**PLANNING BOARD REGULAR AND REORGANIZATION JANUARY 5 2021 AGENDA
CONDUCTED WITH ZOOM
JANUARY 05, 2021 7:00 PM – TUESDAY**

15. UNION AVENUE - SEPE - AFFORDABLE HOUSING APPLICATION

**Re: Manasquan Planning Board Application MSPB #R-1170
Preliminary and Final Major Site Plan Approval w/ Bulk Variance (“Application”)
33, 33 1/2 - 39 Union Avenue, Manasquan, New Jersey
Block 66.02, Lot 31.01 (“Property”)**

**RE: SITE PLAN FOR UNION AVENUE 33, LLC
BLOCK 66.02, LOT 31.01
MANASQUAN BOROUGH PLANNING BOARD
OUR FILE # MQSP10105**

PROJECT NO. SEPE-00010
 DRAWING
 CD-1
 SHEET NO.
 6 OF 9

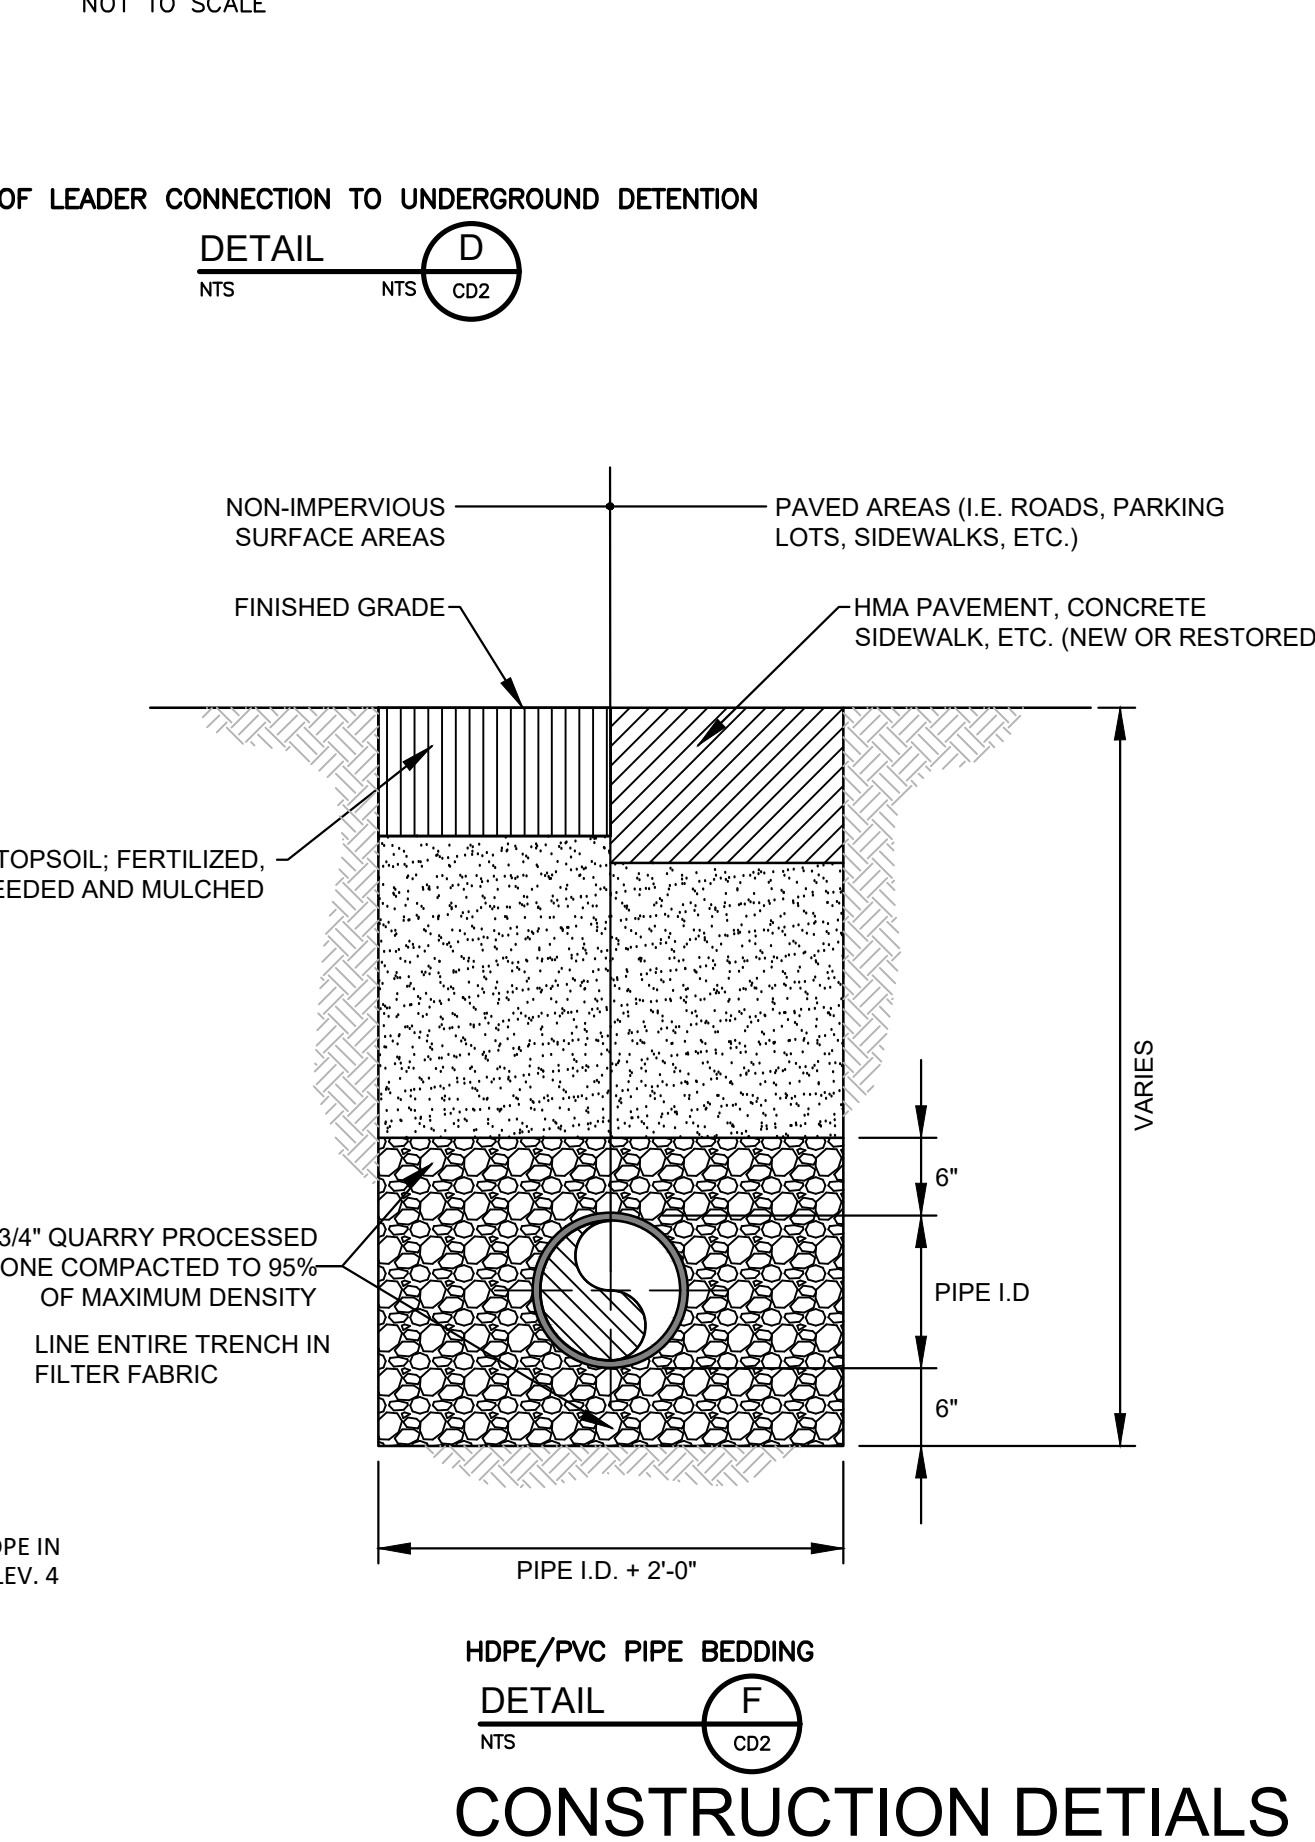
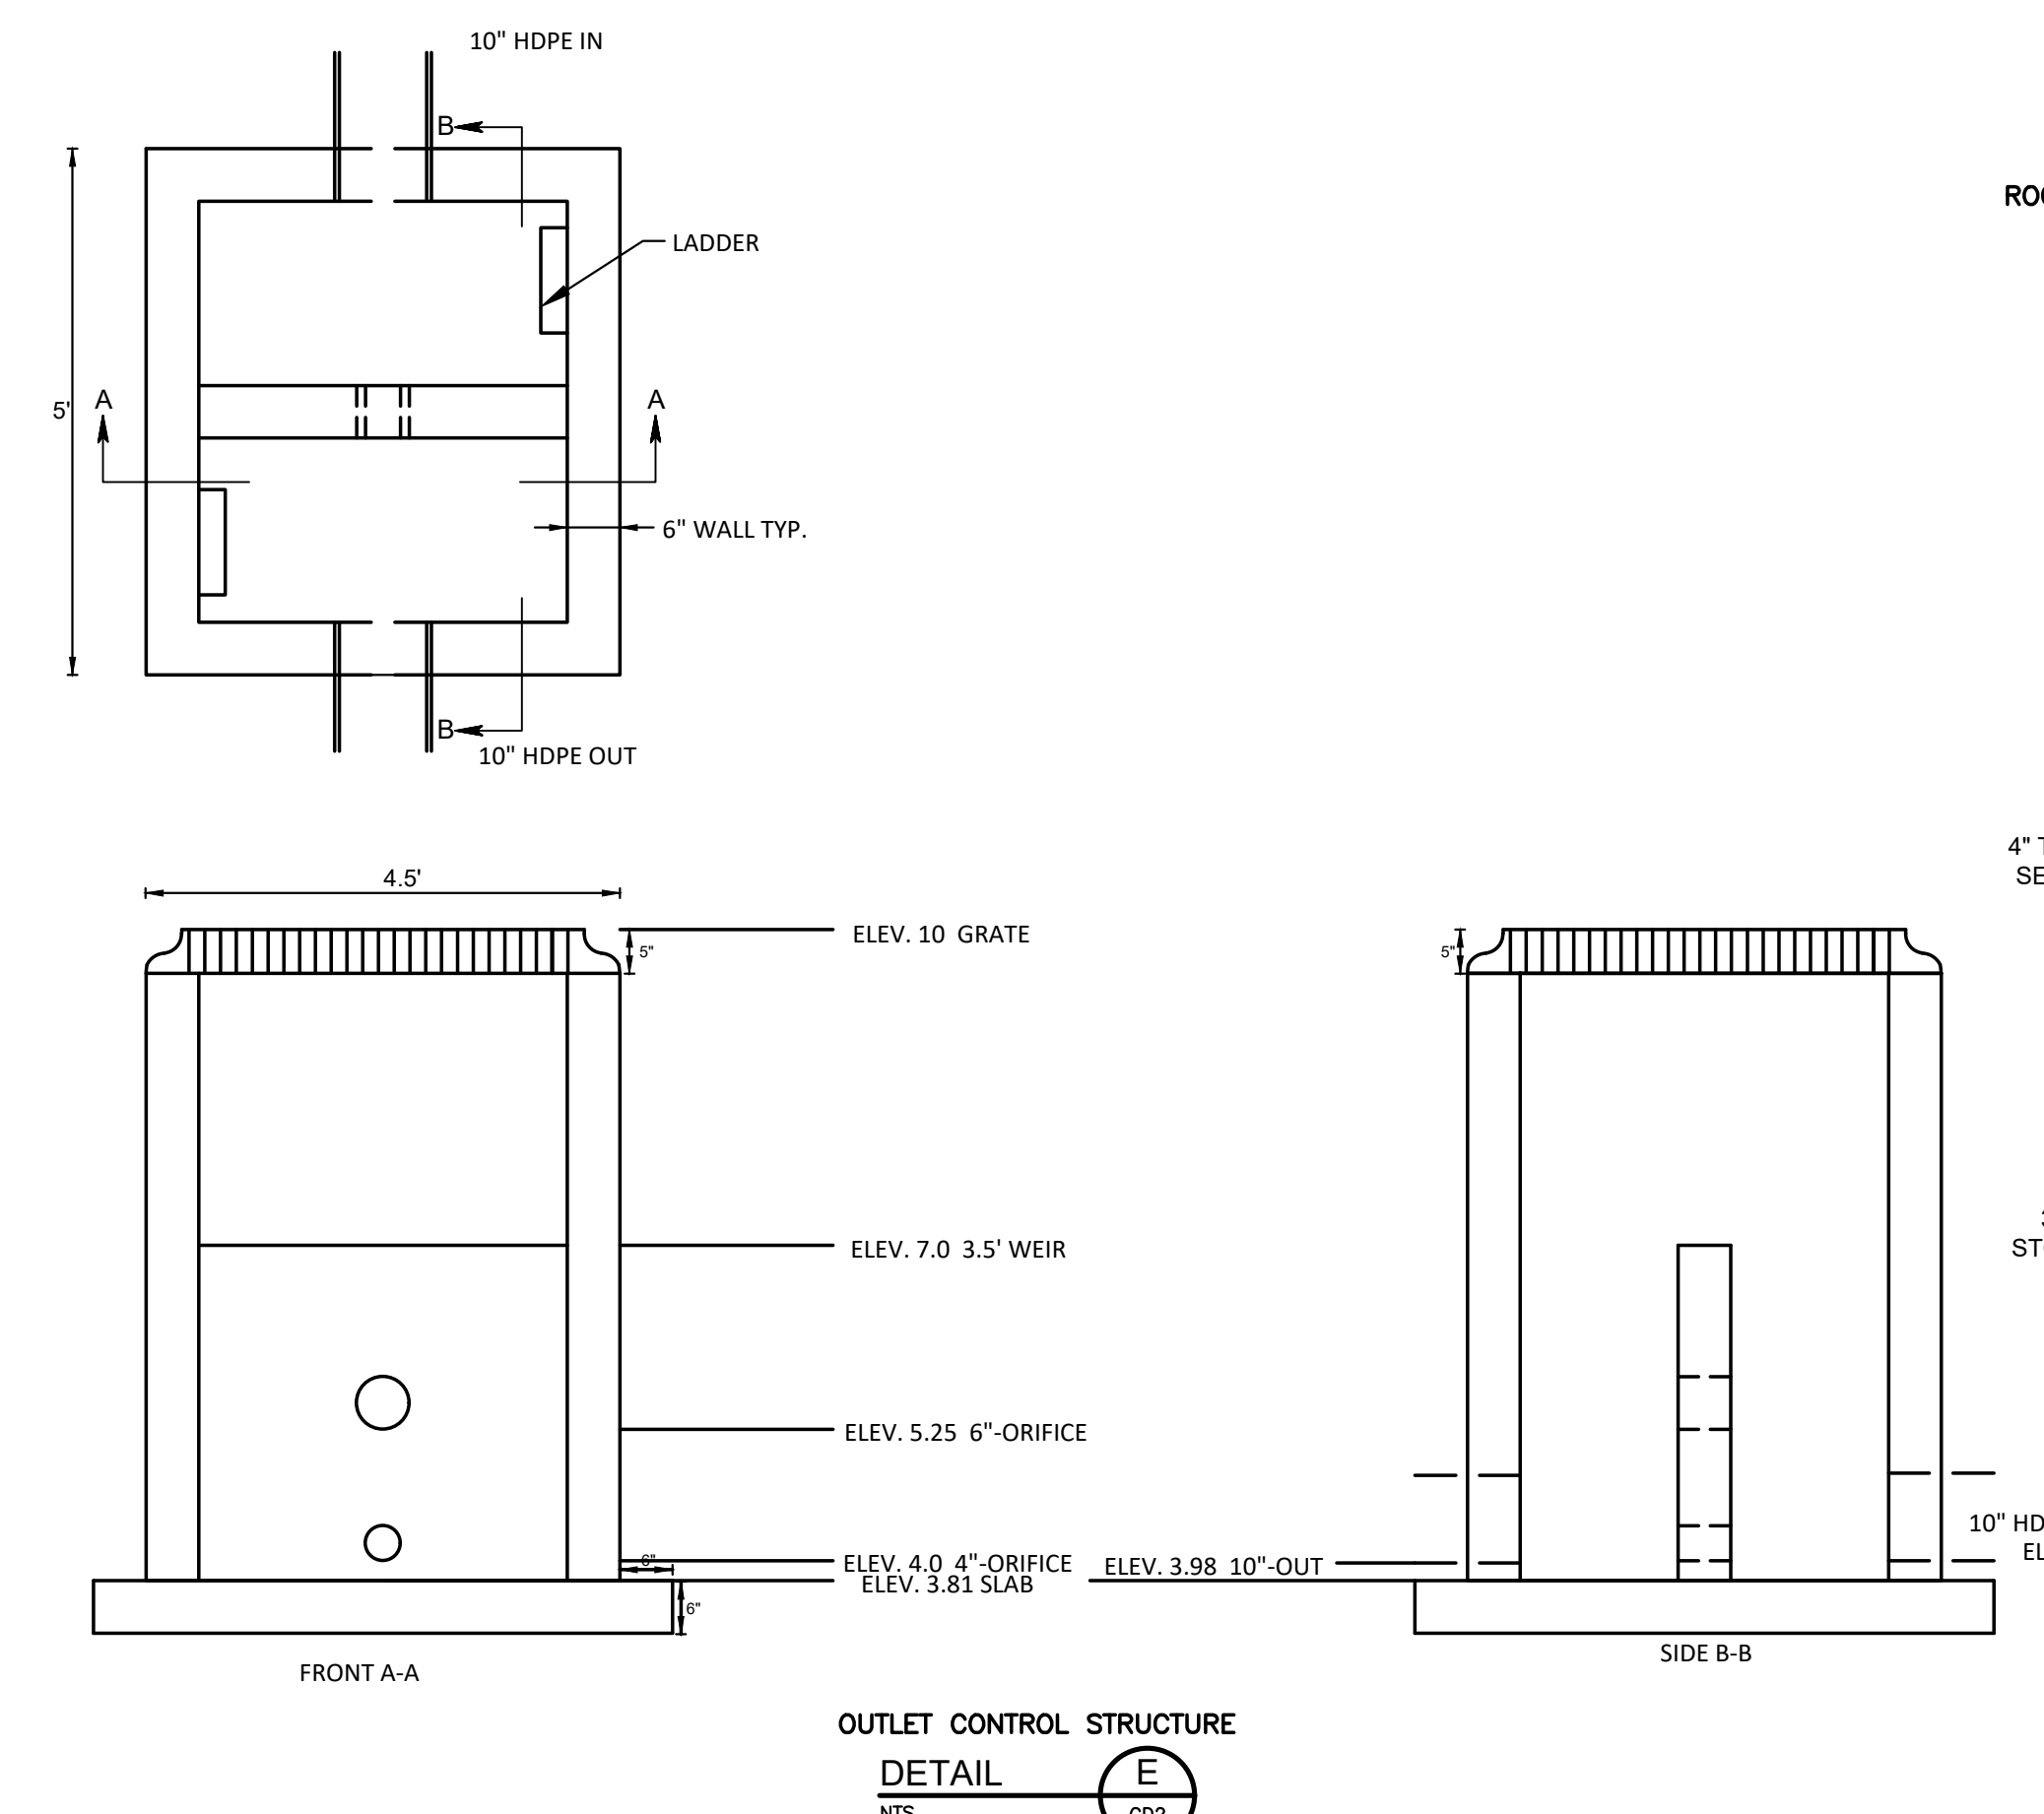
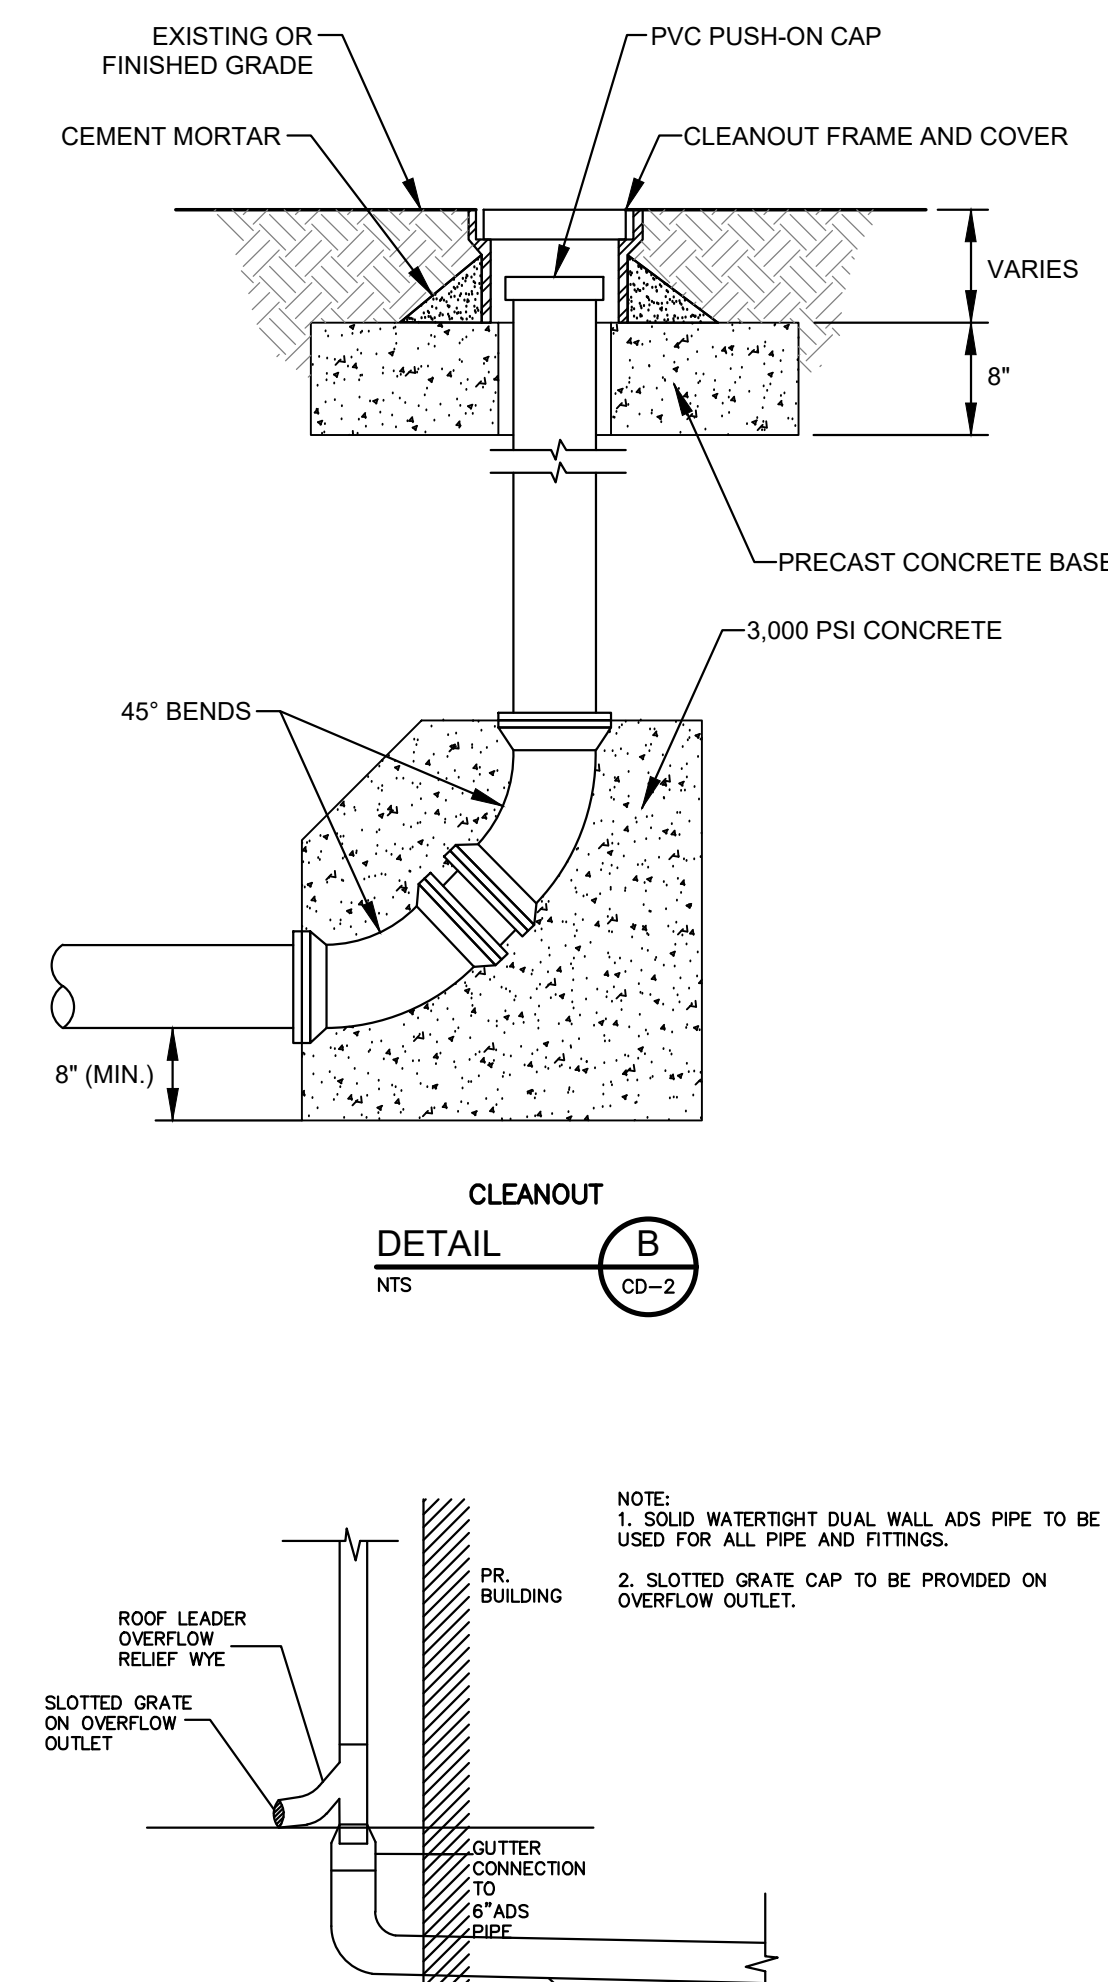
29. *Any sidewalk must be replaced as necessary on Union Avenue **The plans have been revised to show curb and sidewalk replacement on Union Avenue (sheet CD-1).***
